045-0119-00

FIRMWARE UPDATE

For the following TEKTRONIX® instruments:

This product improvement kit provides firmware (U310 and U235) and installation instructions to eliminate errors encountered when using "1 A Transfer" function with 830 Series ROM Packs.

Figure 3. Location of U235 and U310 on the Processor (A1) circuit board.

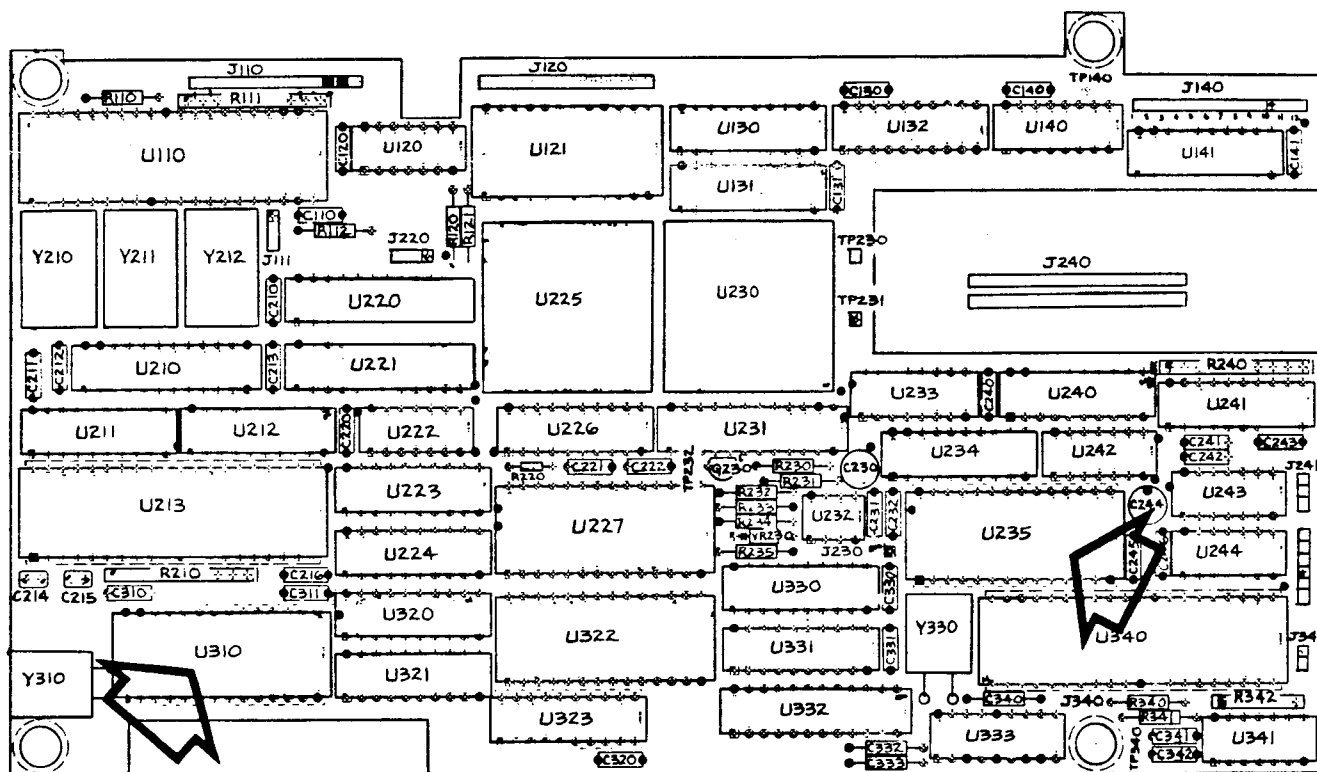
- () 5. Replace U235 with pn 160-3352-05 provided in the kit. Refer to Figure 3 for location of U235 and U310.
- () 6. Replace U310 with pn 160-3182-04 provided in the kit.
- () 7. Reassemble the instrument, reversing disassembly procedure.
- () 8. Affix the identification label, provided in the kit, to the bottom cover (near the center cover-securing screw) to indicate this kit has been installed.
- () 9. For future reference, correct the Electrical Parts List in the Instruction Manual to reflect the changes incorporated by this kit.
- () 10. Refer to the 835/836 Service Manual and perform the LIST-ROM TEST (CSROM and Z8ROM) to verify the correct internal ROMS have been installed as follows:

Z8ROM: PN=3182-04

CSROM: PN=3352-05
